# Washington State Building Code Council

## STATE BUILDING CODE INTERPRETATION NO. 16-07

**CODE:** 2015 International Residential Code

**SECTION:** R302.3/Two Family Dwellings

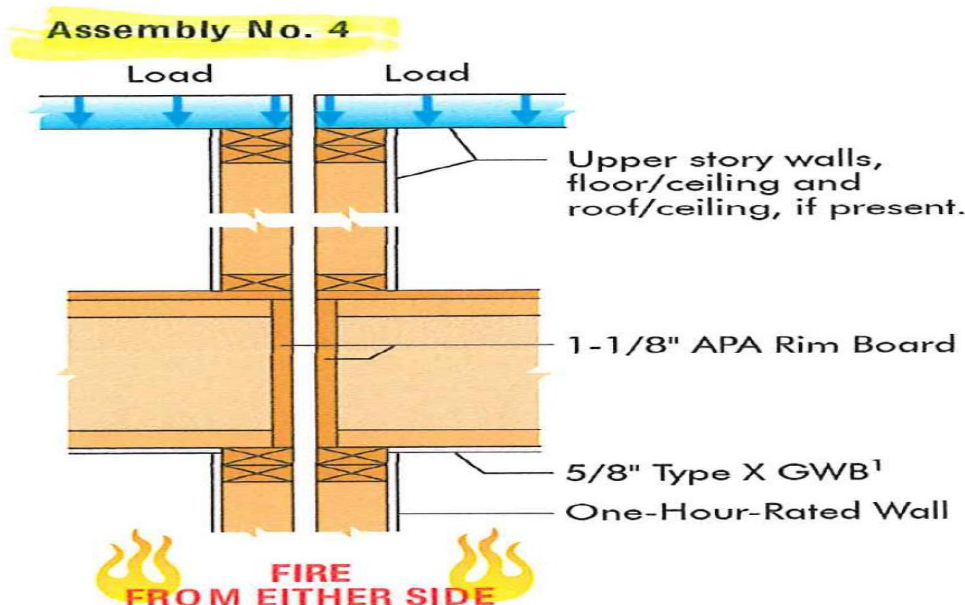
**QUESTION:** I have been requested to evaluate some documentation regarding an alternative method to providing for separation wall continuity within the floor cavity between floors of multi-story two-family dwellings. Attached is the documentation that has been provided to me, the wall and floor being constructed is as shown therein with the joists perpendicular to the wall. In the opinion of the council, do the details provided within the document provide an equivalent method of providing the separation as required by IRC Section R302.3?

**ANSWER:** Yes. "Assembly No 4" appears to meet the 1-hour fire resistant rated requirement in 2015 IRC R302.3. The code specifies that the assembly extend to and be tight against the exterior wall. The assembly is tested to meet ASTM E 119 in the configuration shown and would satisfy that requirement.
